# ZC 17-18 Basement/Cellar Rule

## Observations and Recommendations

*Submitted by Alan Gambrell – 1/18/18*

**FIGURE B § 304.5: DETERMINATION OF GFA FOR THE STORY OF AN ATTACHED BUILDING LOCATED PARTIALLY BELOW GRADE**

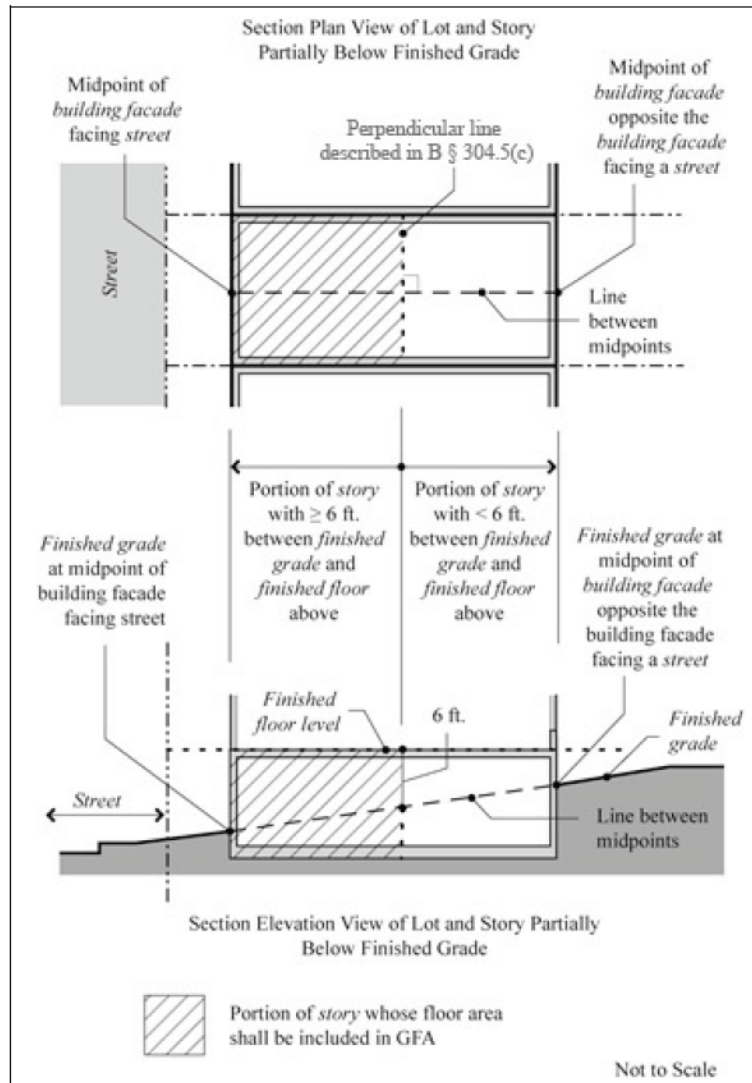
- *ZRR-16 identified GFA/FAR grade measurement point as "midpoint of building façade" (see next page).*
- *ICC measures the grade at the base of the building façade.*
- *Areaways create more light, air and access and, in effect, turn cellars into basements.*
- *Exclusion of areaways as the adjacent finished grade creates an enormous loophole in the basement/cellar measurement rule.*
- *The zoning regulations provide no supporting language for this exclusion.*
- *The areaway distance from façade is only 4' from the façade, according to the DC building code, not 5'.*
- *Neighboring jurisdictions do not support this exclusion.*

**ZRR-16 Figure (removed from Final as were all graphics)**

Figure depicts GFA/FAR grade measurement point as “midpoint of building façade”

*Delete the exception of an areaway from the definition of finished grade.*

*Revise the definition of Grade, Finished as: Grade, Adjacent Finished: **Grade, Finished**: The ground directly abutting the perimeter of a building or structure/outside the building area.*
